FINAL PLAT

ELLSON COURT ADDITION

RE: SUB 2000-56 -- One-Step Final Plat of ELLSON COURT ADDITION

RE: SUB 2000-56 -- One Step Final Plat of ELLSON COURT ADDITION

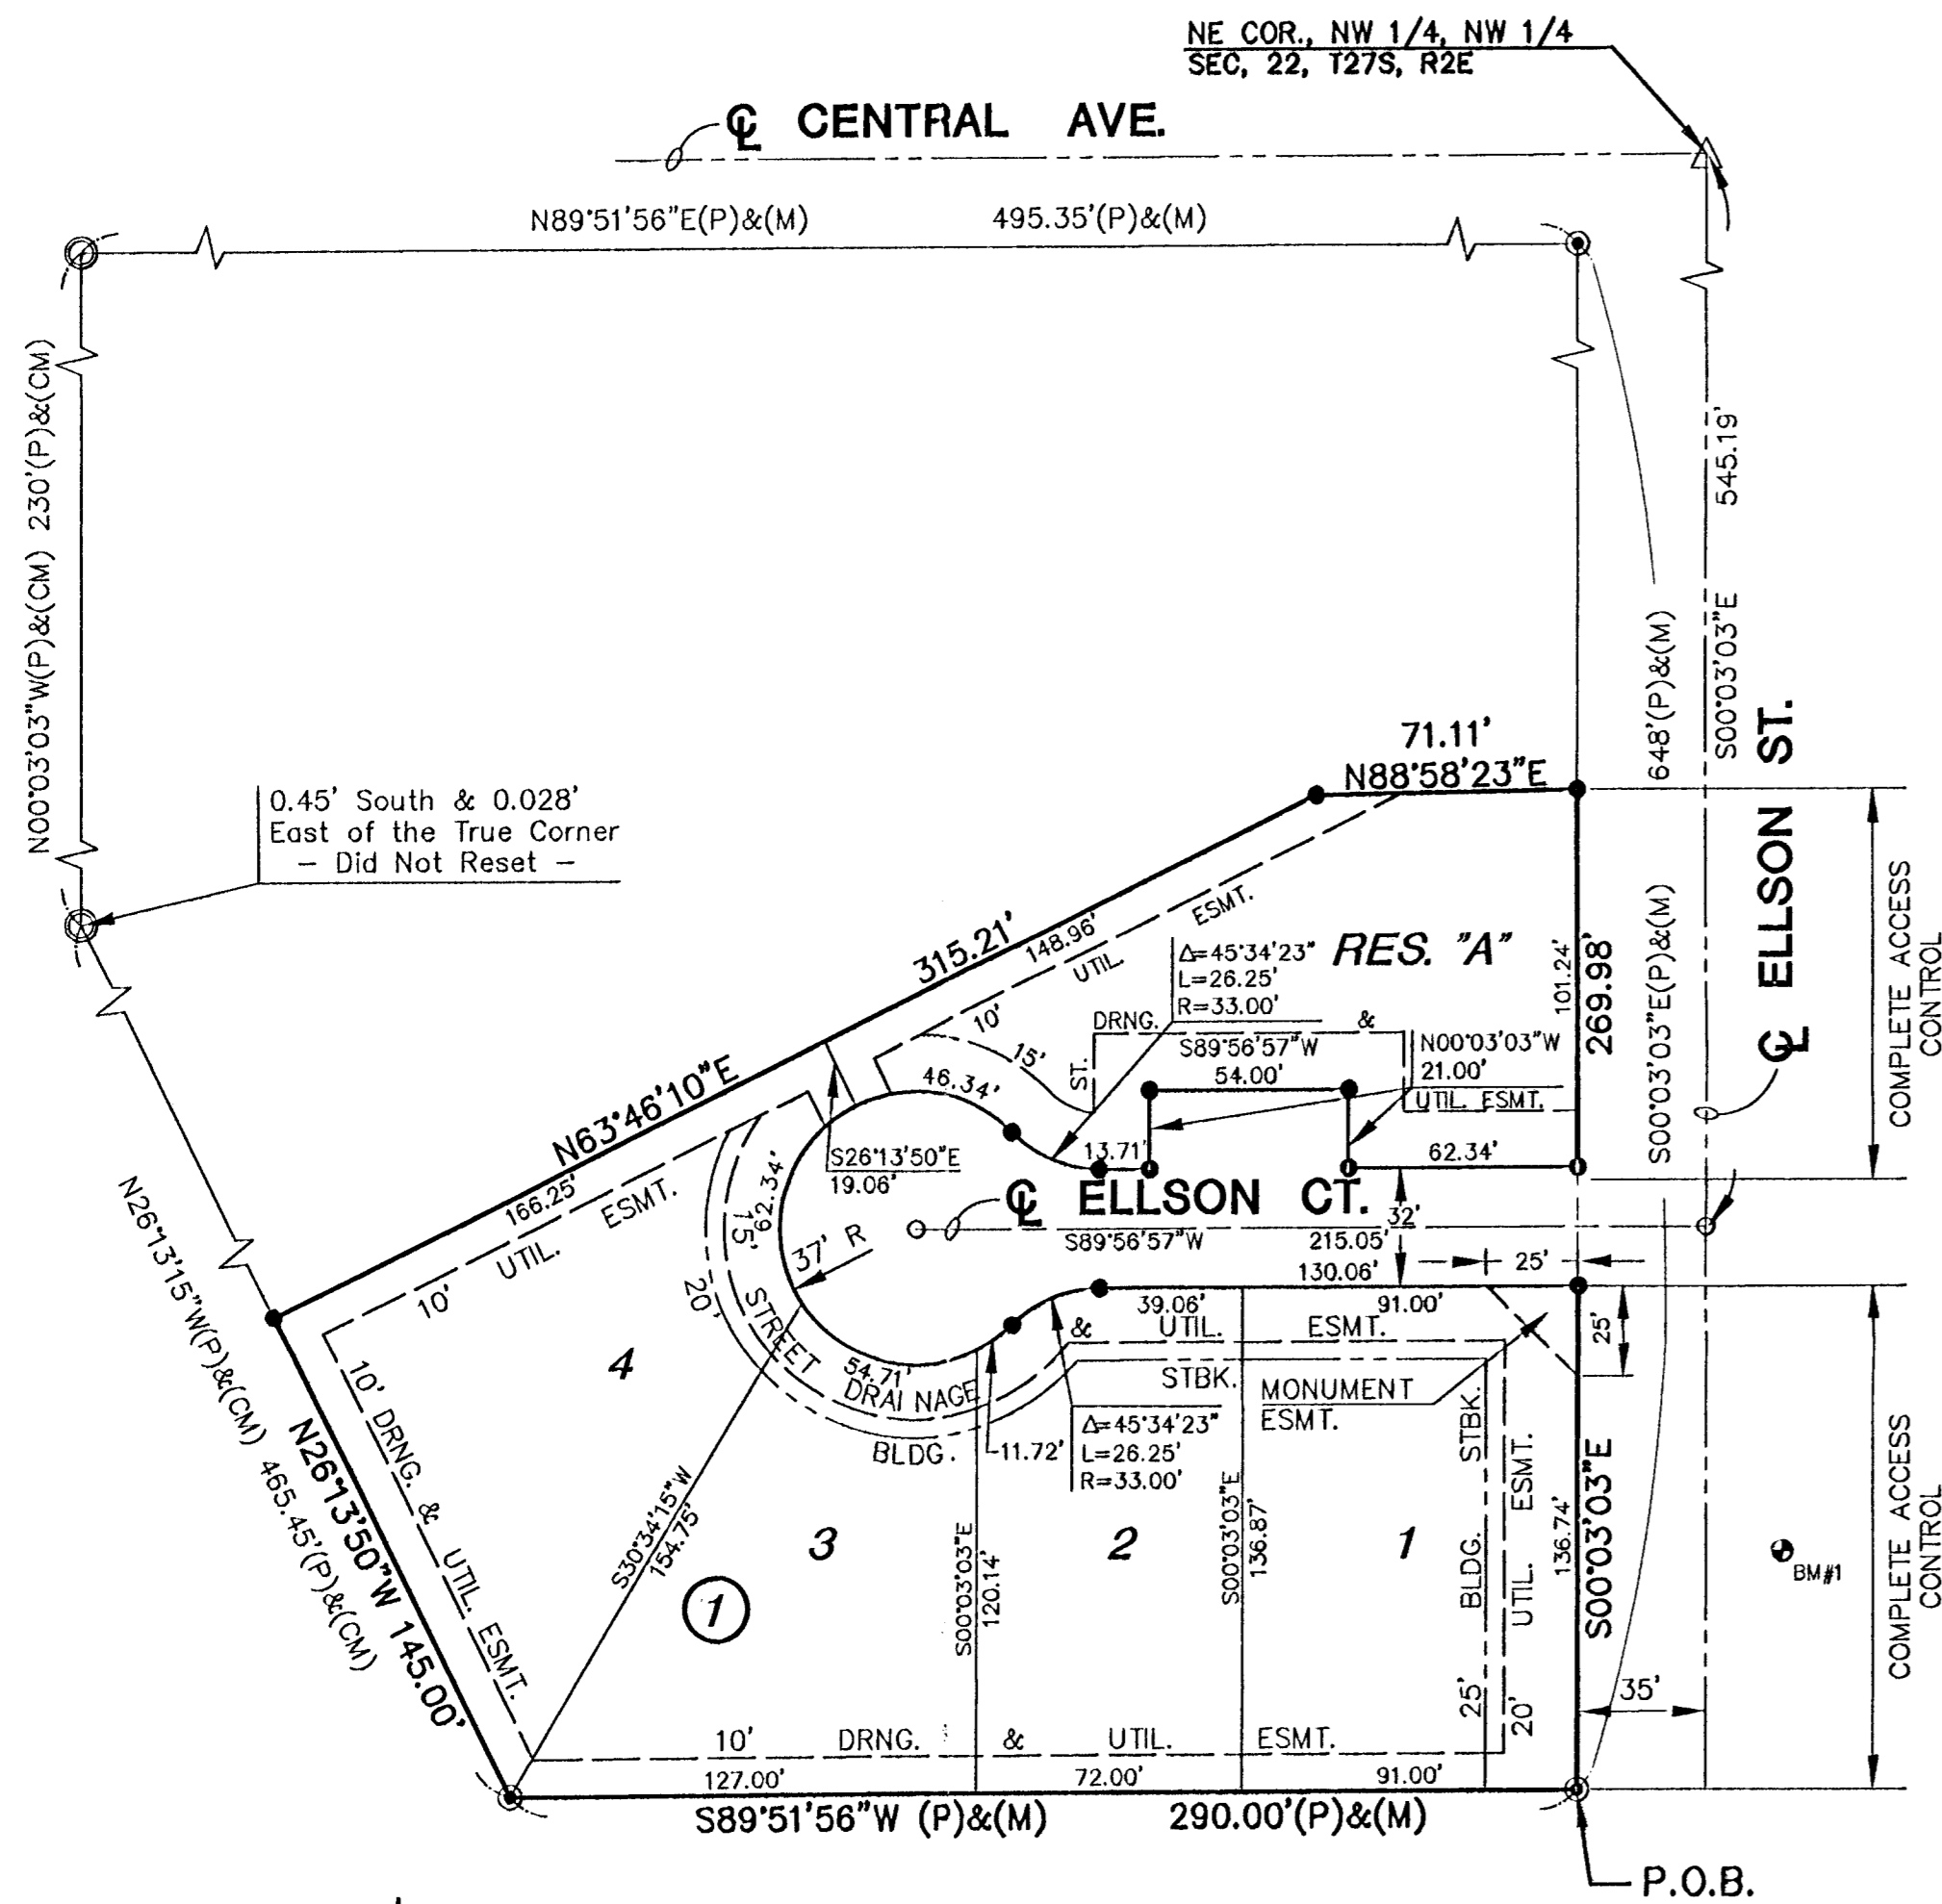
- E. City Engineering needs to comment on the status of the applicant's drainage plan. The drainage plan is approved.
- F. A minimum pad elevation as shown on New Life Christian Church Addition of 1366.4 MSL (179 City Datum) needs to be added.

- G. A benchmark needs to be added.

- I. The dimension on the east line of Lot 5, Block 1, needs to be changed from 230.94' to 155.72'.
- J. Provisions shall be made for ownership and maintenance of the proposed reserves. The applicant shall either form a lot owners' association prior to recording the plat or shall submit a covenant stating when the association will be formed, when the reserves will be deeded to the association and who is to own and maintain the reserves prior to the association taking over those responsibilities. The applicant will eliminate Reserve B from the final tracing.

- M. The applicant shall guarantee the paving of the proposed interior street.
- N. Access control except one opening" should be deleted and replaced by complete access control being platted for the plat's frontage along Ellson.

- O. The building setback line should be denoted by a dashed line.
- P. Traffic Engineering shall comment on the parking easement for back-out parking that is platted within a street curve. The Subdivision Regulations require parking easements to be a minimum of 20 feet deep and have a maximum street frontage of 50 feet. The perimeter of the parking easements shall be redrawn to comply with these requirements. The applicant has agreed to revise the parking easement dimensions.

- DD. *A sewer easement needs to be platted through Lot 5 and Reserve A to cover an existing sewer line.*
